HISTORIC AND DESIGN REVIEW COMMISSION

HDRC CASE NO: 2024-287
ADDRESS: 128 ADAMS ST
LEGAL DESCRIPTION: NCB 932 BLK 1 W 150 FT OF 13
ZONING: RM-4, H
CITY COUNCIL DIST.: 1
DISTRICT: King William Historic District
APPLICANT: Nathan Manfred/French and Michigan
OWNER: Robert Lozano/LOZANO ROBERT A & LOZANO CRISANTA GUERRA
TYPE OF WORK: Second-story, rear porch enclosure
APPLICATION RECEIVED: July 22, 2024
60-DAY REVIEW: September 20, 2024
CASE MANAGER: Edward Hall
REQUEST:

The applicant is requesting a Certificate of Appropriateness for approval to enclose a rear, second level porch.

2 128 ADAMS - PORCH REMODEL PLAN
SCALE: 1/4" = 1'-0"

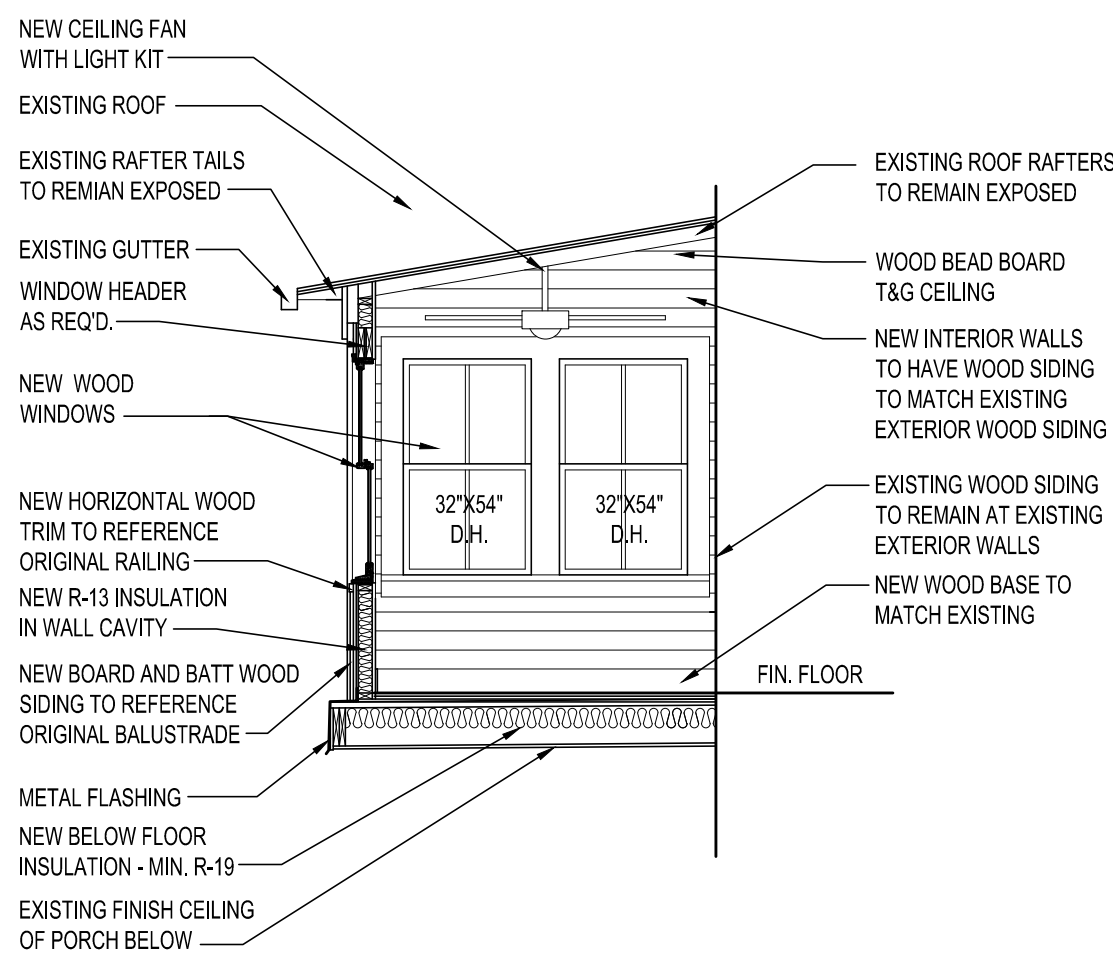
- c. PORCH INFILL – The applicant has proposed to enclose a rear, second level porch at the southeast corner of the historic structure. The Guidelines for Exterior Maintenance and Alterations 7.A.i. says to preserve porches, balconies, and porte-cocheres. The Guidelines for Exterior Maintenance and Alterations 7.B.ii. notes that applicants should refrain from enclosing side and rear porches, particularly when connected to the main porch or balcony. When alterations are made to rear porches, the design should result in a space that continues to read as a porch. The applicant has proposed a design which retains the existing rafter tails, columns, features a change in siding profile at the location of the existing balustrade and features windows that relate to the previously unobscured open space. Generally, staff finds that the proposed design allows the enclosed porch to continue to read as a porch.

Staff recommends approval based on findings a through d, as submitted.

6 TYPICAL WALL DETAIL AT EXISTING COLUMNS
SCALE: 1" = 1'-0"

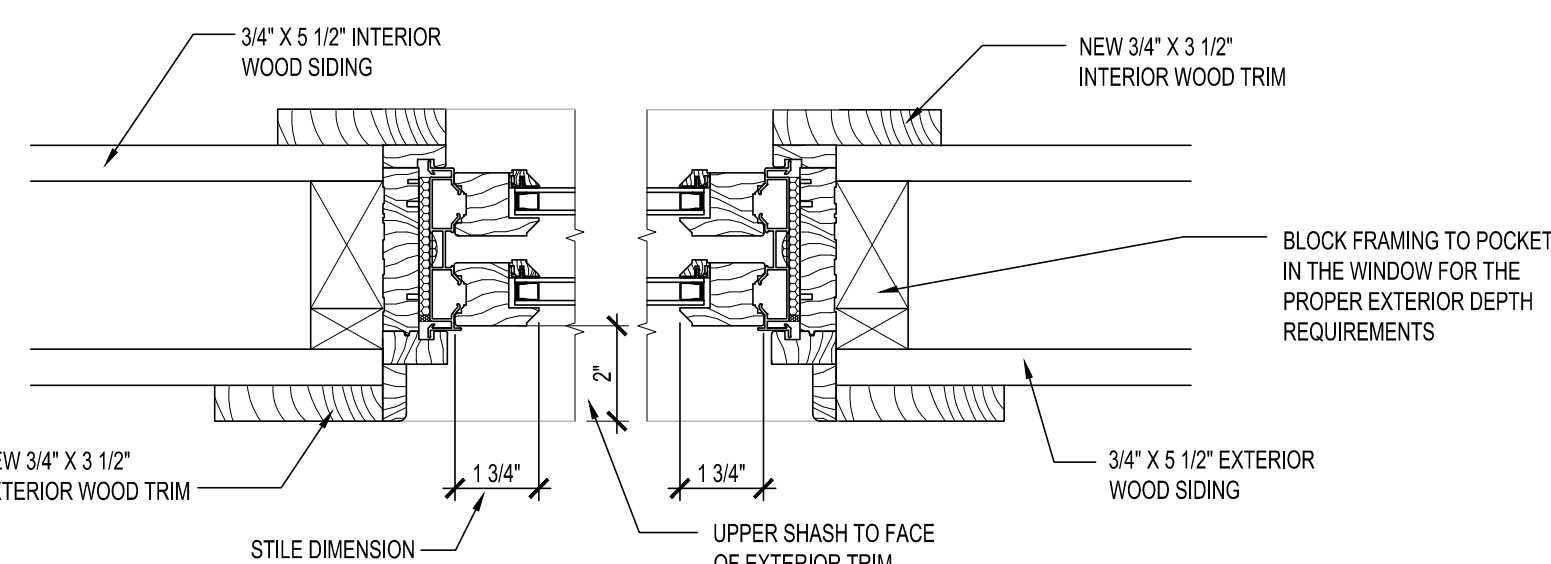
- iii. That the existing columns remain in place. ***This stipulation has been met.***
 - iv. That the proposed design incorporates siding infill between the columns at the height of the existing balustrade. ***This stipulation has been met.***

HERITAGE SERIES | DOUBLE HUNG

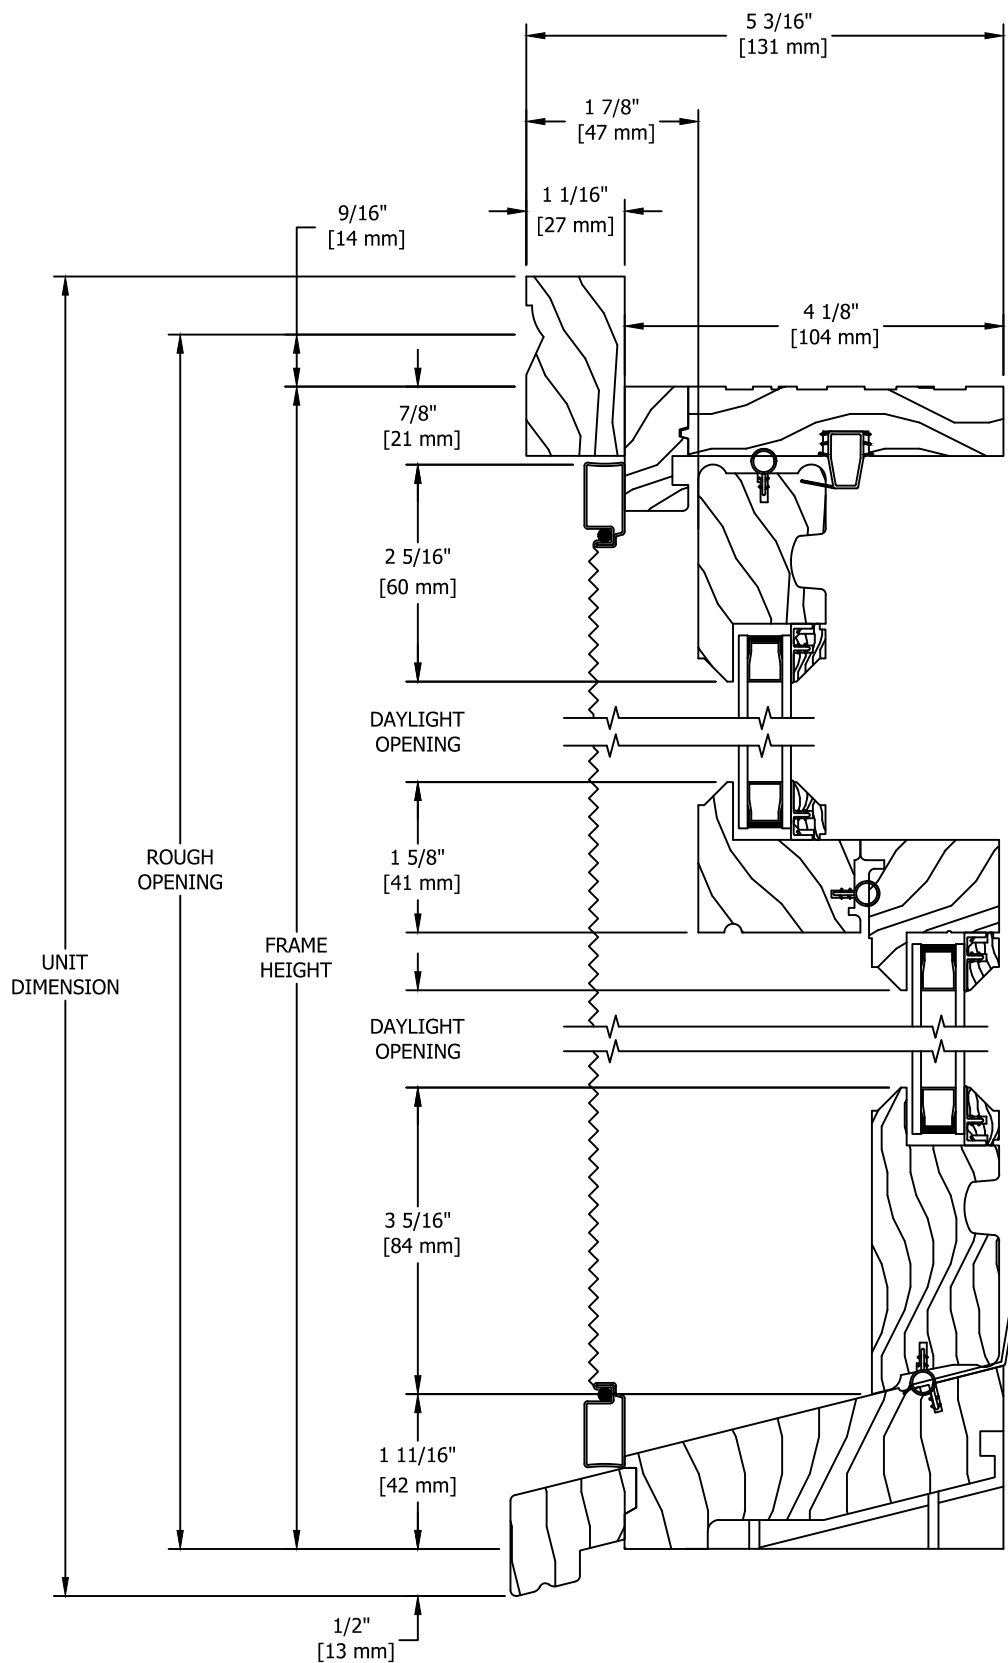
- d. WINDOWS – The applicant has proposed to install wood windows that staff finds generally meets the adopted standards.
